# PLANNING AND ZONING BOARD (PZB)

## CITY OF DELRAY BEACH

## ---STAFF REPORT---

**ITEM:** **Beacon Plat** – Recommend to the City Commission certification of the final plat associated with the Beacon subdivision located on the east side of North Swinton Avenue, south of Lakeview Baptist Church and north of St. Joseph's Episcopal School.

# **BEACON PLAT** BEING A REPLAT OF A PORTION OF SECTIONS 4 AND 5, TOWNSHIP 46 SOUTH, RANGE 43 EAST, CITY OF DELRAY BEACH, PALM BEACH COUNTY, FLORIDA. MAY, 2018 SHEET 2 OF 3

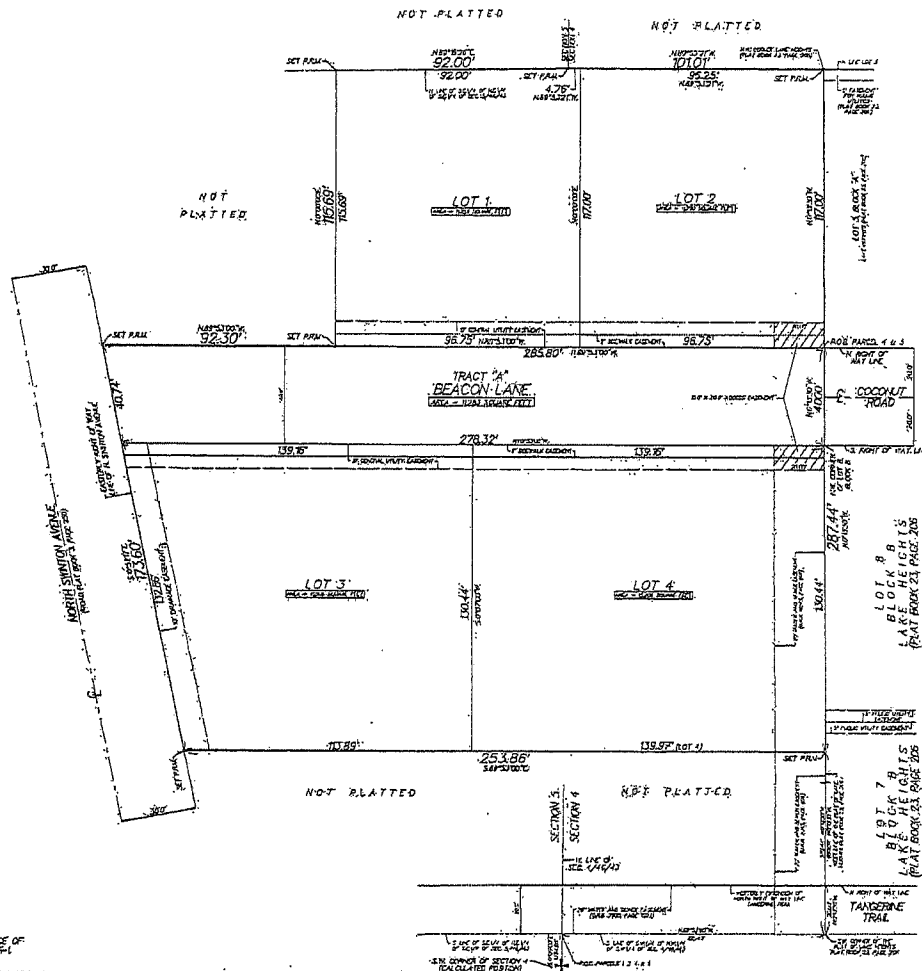
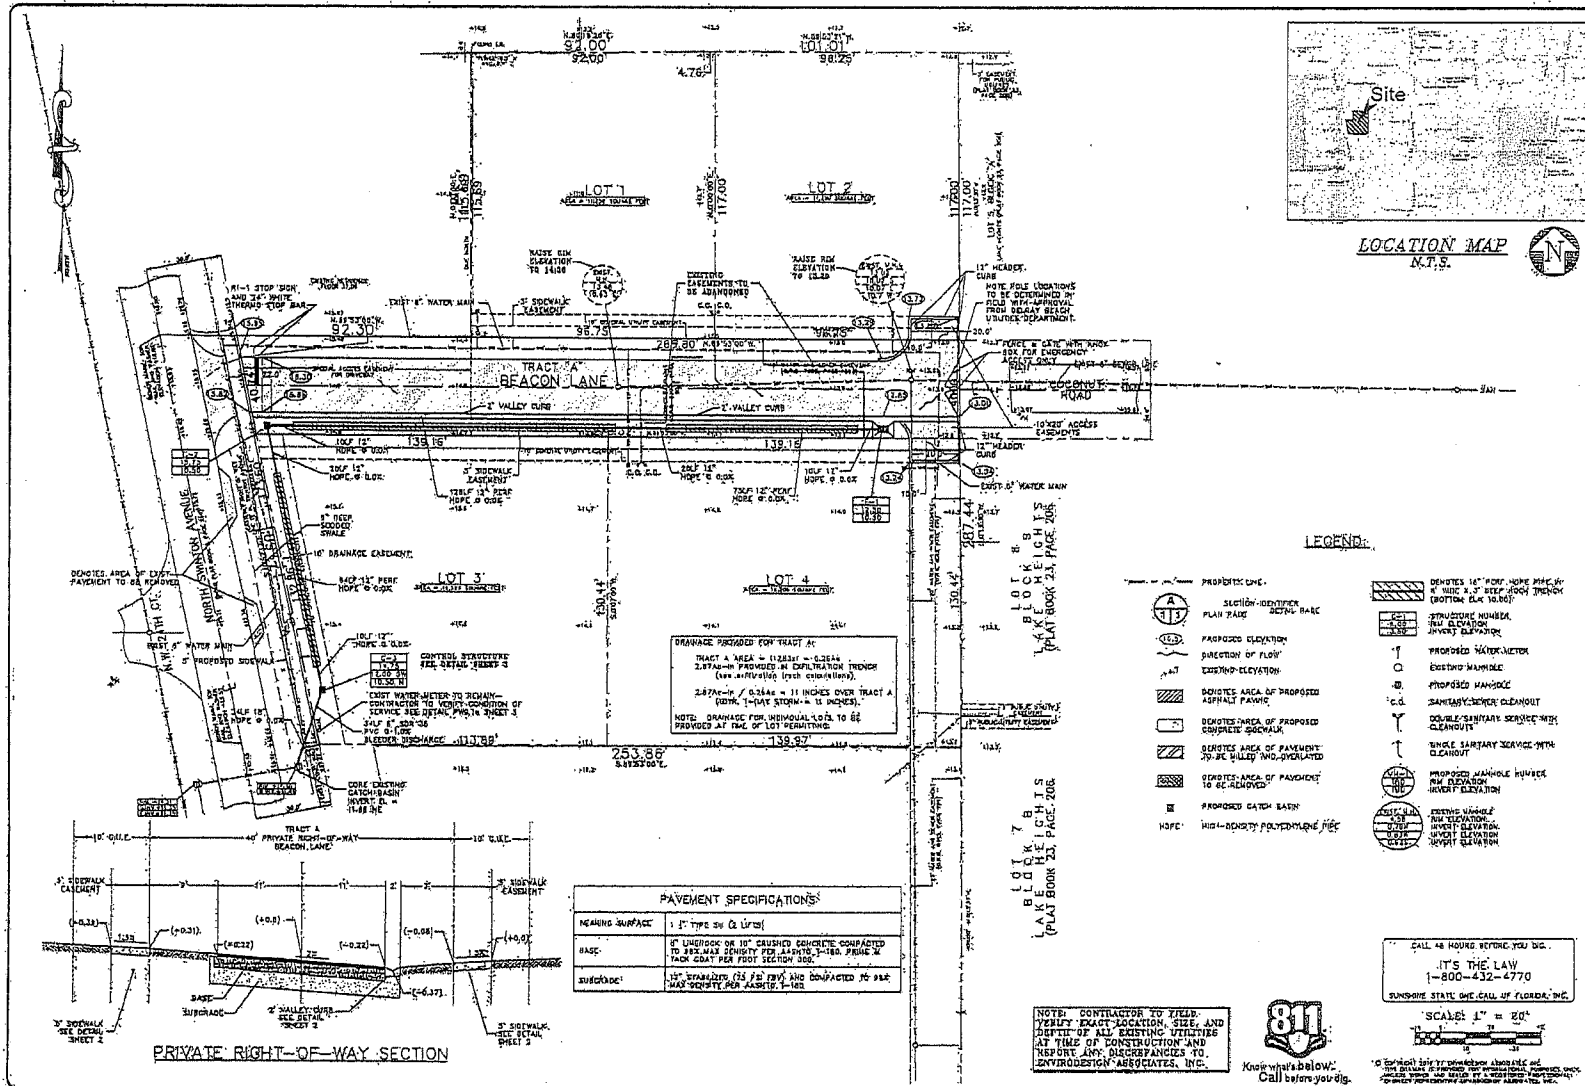
- c. Sheet "1 of 2" of the proposed Beacon Plat for the currently proposed 4 units does not appear to provide accurate descriptions for the reconfigured Lots 1-4. The geographic location for Lots 3 and 4 have changed since the original 5 lots proposal, but do not appear to be modified. Also, there is no longer a "Parcel 5".

- d. Since Sheet "2 of 2" of the Beacon Plat identifies "Lots" 1-4, the terminology on Sheet "1 of 2" should not reference "Parcel" 1-4. Change terminology to "Lots" for consistency.
